SUBJECT: Responds to NRC 790801 request for addl info re
 recirculation sump. Model test to be completed by Nov, 1979.
 Sump location drawings encl.

September 24, 1979
AEP:NRC:00260

Donald C. Cook Nuclear Plant Units No. 1 and 2
Docket Nos. 50-315 and 50-316
License Nos. DPR-58 and DPR-74
Request for Additional Information Regarding Recirculation Sump

FIGURE 1 LOCATION OF SUMP WITHIN CONTAINMENT BUILDING

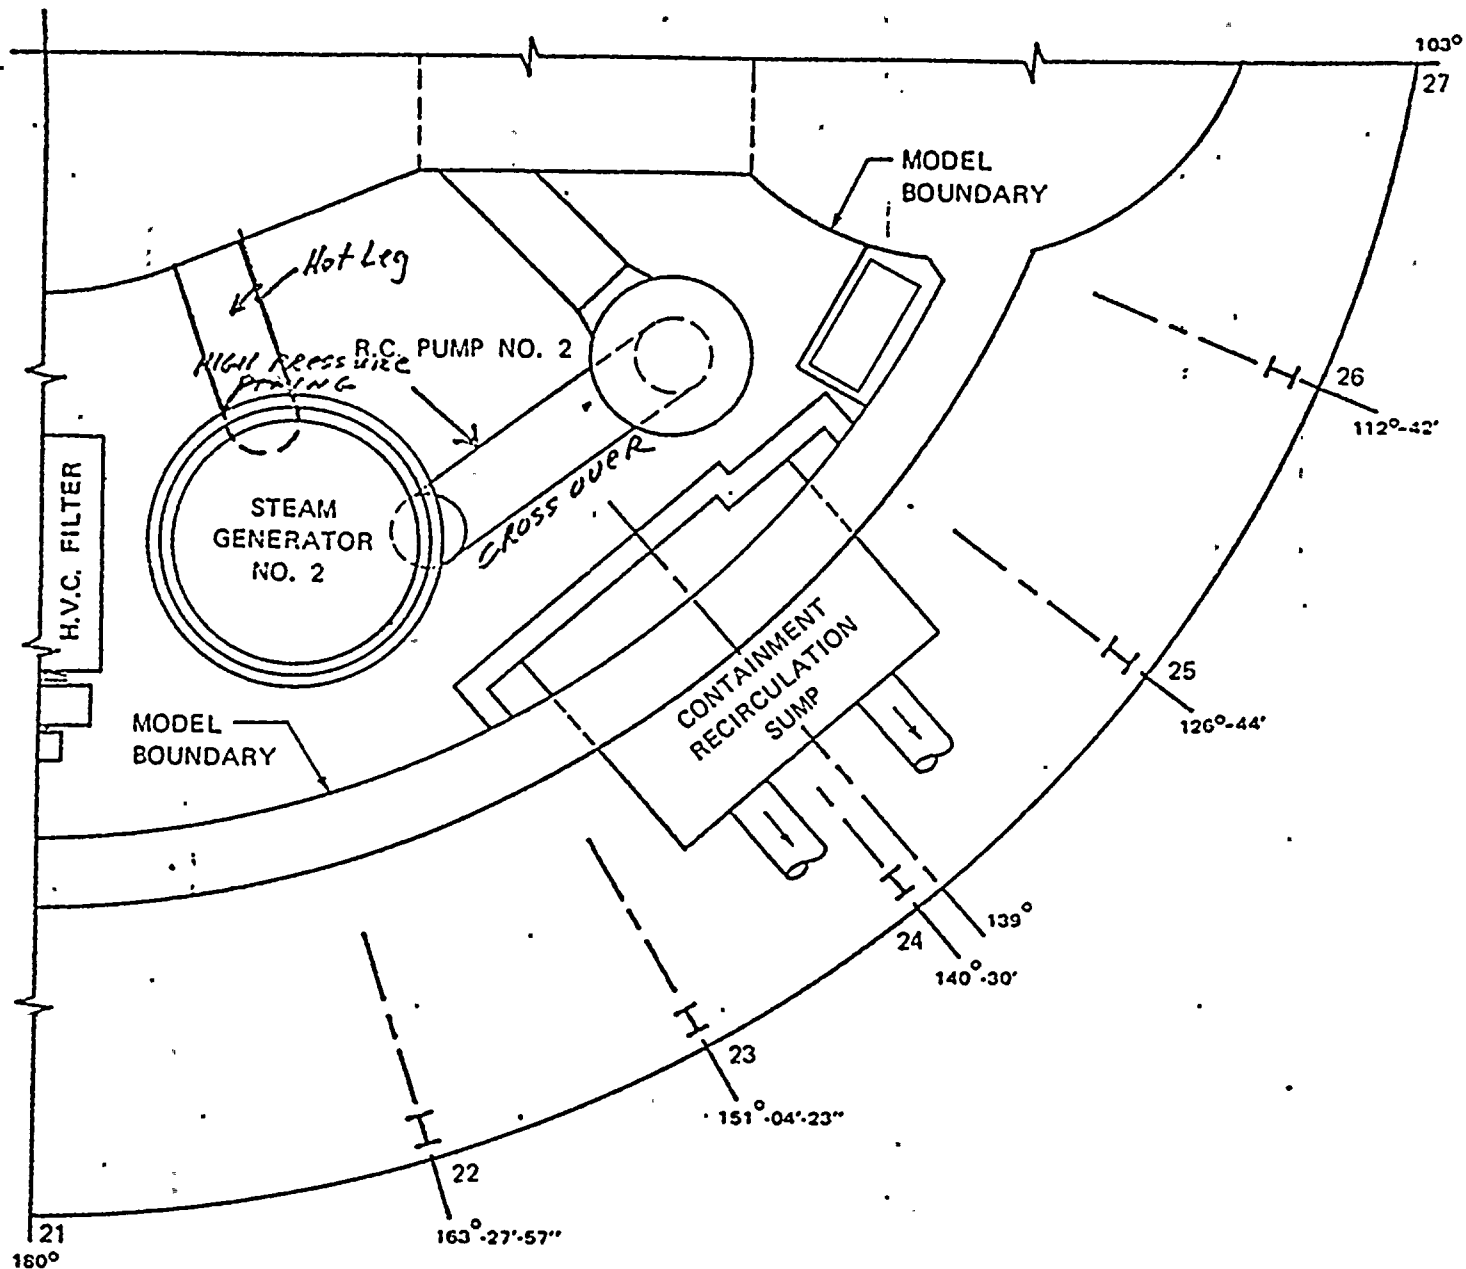
This letter is in response to a Request for Additional Information enclosed in Mr. A. Schwencer's letter of August 1, 1979 concerning the performance of the D.C. Cook Plant recirculation sump under LOCA/jet impingement conditions.

In response to Item 2 of the subject request, Figures 1 and 2 of Attachment 1 are enclosed. The figures are marked to indicate break locations being considered and containment water levels at various switchover points. The piping segments shown in Figure 2 which is an enlargement of Section B-9 of FSAR Figure 5.2-5 represent the only high pressure piping in the vicinity of the recirculation sump.
